UNITED STATES
DEPARTMENT OF THE INTERIOR
BUREAU OF LAND MANAGEMENT

FORM APPROVED
OMB No. 1004-0137
Expires: July 31, 2010**SUNDRY NOTICES AND REPORTS ON WELLS**
Do not use this form for proposals to drill or to re-enter an abandoned well. Use Form 3160-3 (APD) for such proposals.5. Lease Serial No.
NMNM29234

☐ Oil Well ☐ Gas Well ☒ Other: T & A WELL8. Well Name and No.
LOTOS FEDERAL # 42. Name of Operator
CHEVRON U.S.A. INC.9. API Well No.
30-015-275933a. Address
15 SMITH ROAD
MIDLAND, TX. 797053b. Phone No. (include area code)
432-687-7375 LEE ROAK10. Field and Pool or Exploratory Area
SANDS DUNES W. DELAWARE

LOTOS Federal No. 4

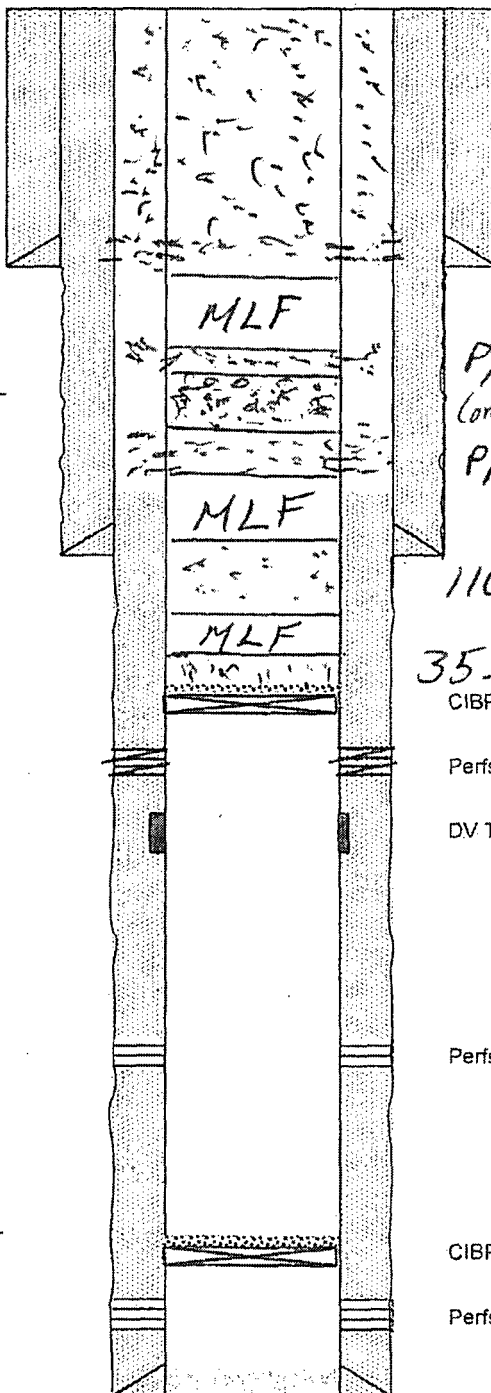
Size: 8-5/8"
 Wt., Grd.: 24 & 32#, J-55
 Depth: 4335'
 Cmt: 1810
 Circulate: Yes ?
 TOC: Surface
 Hole Size: 11"

P/S 90SX 1,690'-1,370' TAG
 (combine plugs & 2410-870' Tag)
 P/B 235SX 3,510'-2,700' TA
